**Public Hearing
CITY OF AUSTIN
RECOMMENDATION FOR COUNCIL ACTION**

SUBJECT: Conduct a public hearing and consider action on an appeal Ed King (Long Canyon Home Owners Association, Phase I) and Joseph Konopka (Long Canyon Home Owners Association, Phase II/III) of the Zoning and Platting Commission's decision to grant a Hill Country Roadway Site Plan with waiver/variances for Potter's Dentistry at 7901 FM 2222 (site plan no. SPC-04-0022A).

POTTER'S DENTISTRY SITE PLAN APPEAL

**ZONING & PLATTING COMMISSION SITE PLAN
HILL COUNTRY SITE PLAN REVIEW SHEET**

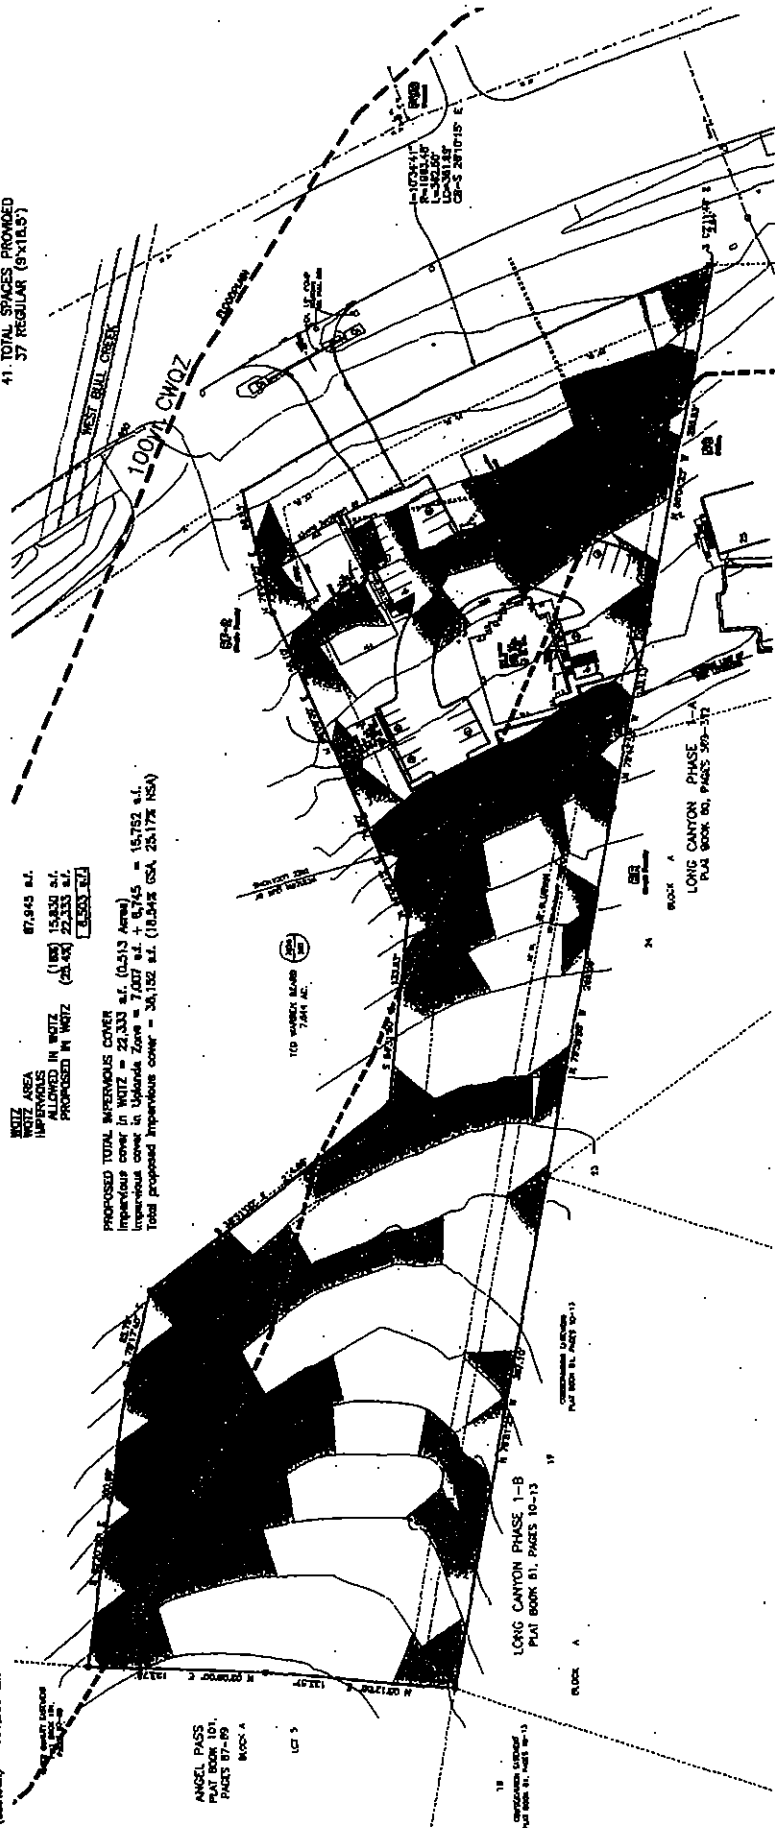
PROPOSED TOTAL IMPERVIOUS COVER
 Impervious cover in WQZ = 22,333 s.f. (0.313 Acres)
 Impervious cover in Upland Zone = 7,007 s.f. + 8,745 s.f. = 15,752 s.f.
 Total proposed impervious cover = 38,085 s.f. (18.54% G.S.A. 25.17% N.S.A.)

This correspondence is being submitted as a revised request for a variance from Section 25-8-423 (B) and Section 25-8-423 (C) of the City of Austin Land Development Code for the above referenced Site Plan Application. The variance request is to allow increased impervious cover in the water quality transition zone. The increased impervious cover being requested is for approximately 6,503 s.f. (allowable is 15,830 s.f. and proposed is 22,333 s.f.).

Original Site Plan. Three Buildings

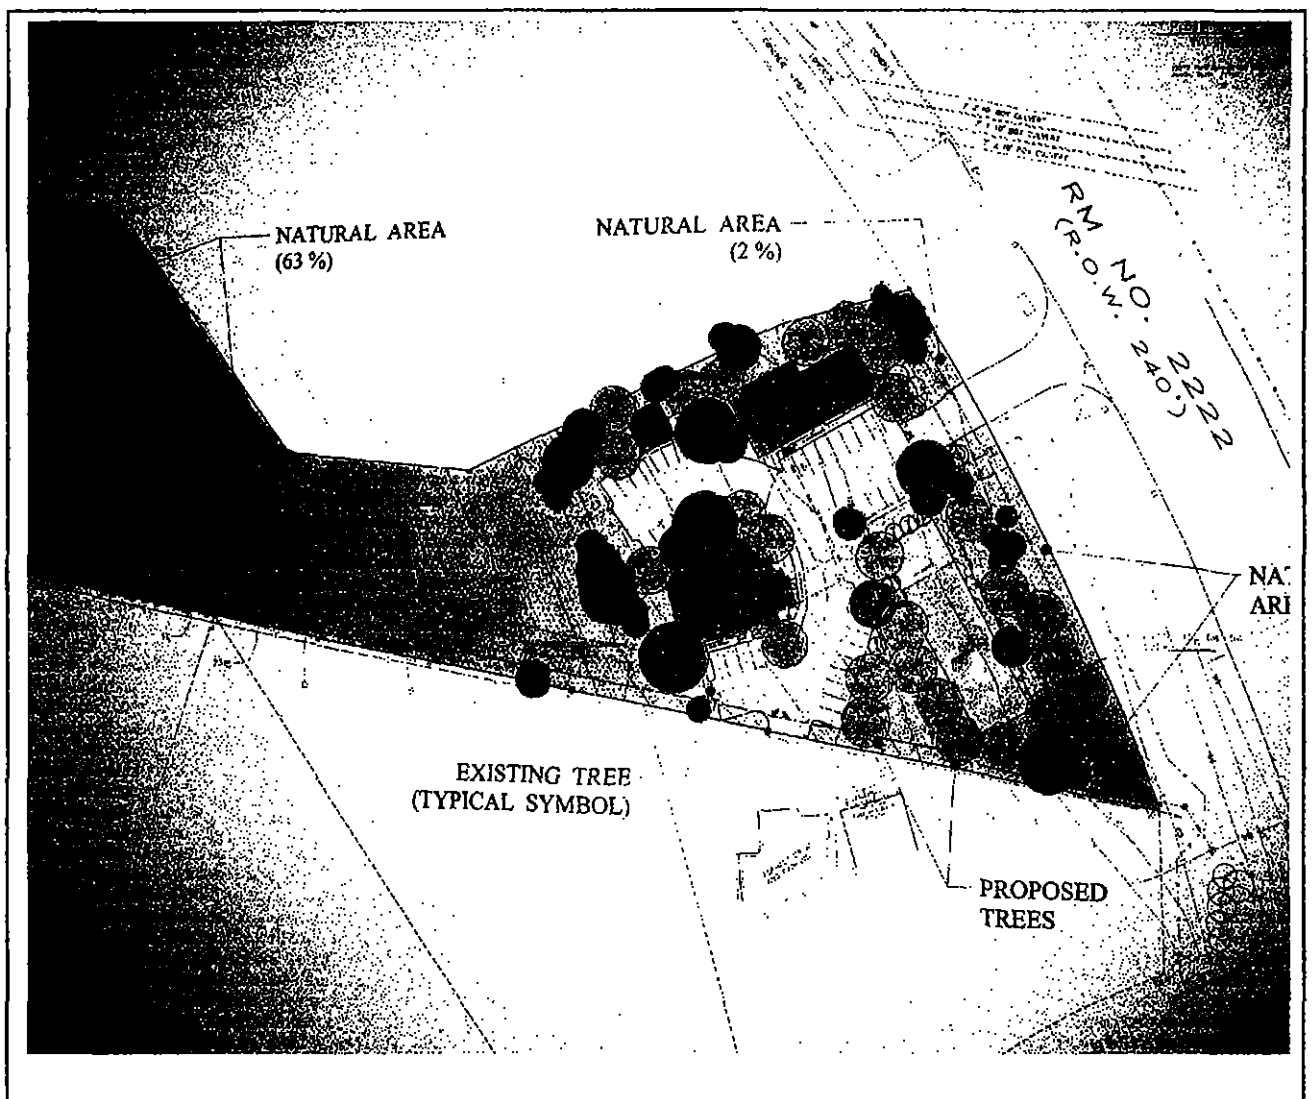
Attached for your review are 29 letters of support for Site Plan SPC-04-0022A, Potter Dentistry. Each letter was obtained after meeting one-on-one with the endorsing party and discussing the project. Included with the letters are three documents that show the location and site plan (titled "Project Location", "Original Site Plan: Three Buildings", and "Final Site Plan: Reduced to Two Buildings").
